Subject: Crystal River Unit 3
Docket No. 50-302
Operating License No. DPR-72
Request for Permanent Exemption from Installation of
a Reactor Vessel Head Vent

ITEMS TO BE ADDRESSED BY FLORIDA POWER CORPORATION ARISING FROM MEETING WITH NRC ON JULY 20, 1984

FLORIDA POWER CORPORATION'S RESPONSES TO ITEMS LISTED IN ATTACHMENT 1

FIGURE 1

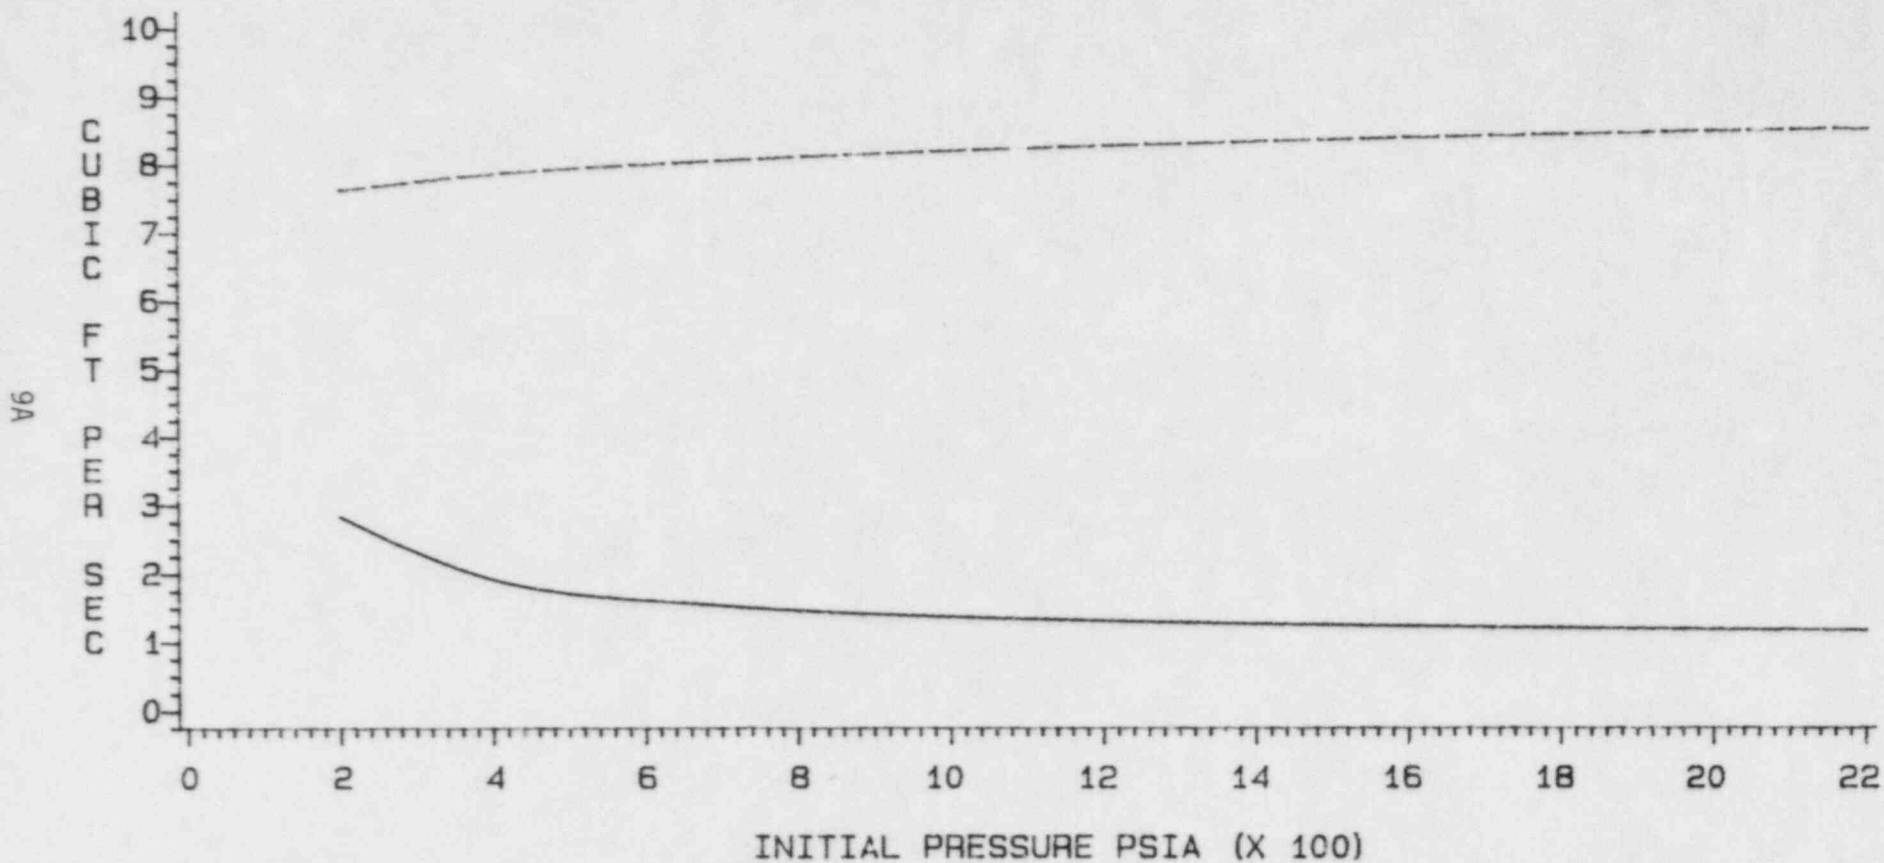
- e) Under the conditions stated in 4d, above, the maximum calculated RCS depressurization rate for CR-3 is about 1150 psi/hr.
- f) Assuming depressurization of CR-3 from an initial value of 2200 psia (conservatively high) to a final value of about 400 psia, the rates of non-condensable gas evolution were calculated from the upper head and from the gas-saturated coolant. These combined evolution rates were compared to the rates which would be vented through the two hot leg high point vents. The calculated vent rates far exceed the calculated evolution rates as shown in Figure 1.

Provide information on how the operators limit the depressurization rate following an ICC event to assure that natural circulation is not interrupted with the present size hot leg vents.

The current limit is a temperature reduction rate of 10°F/hr. Depressurization rates are not currently specified for recovery from ICC. However, procedure revisions are planned which will limit depressurization following ICC to the use of the pressurizer high point vent, rather than the PORV. Results of calculations consistent with these assumptions are shown in Figure 1 (See also Attachment 3).
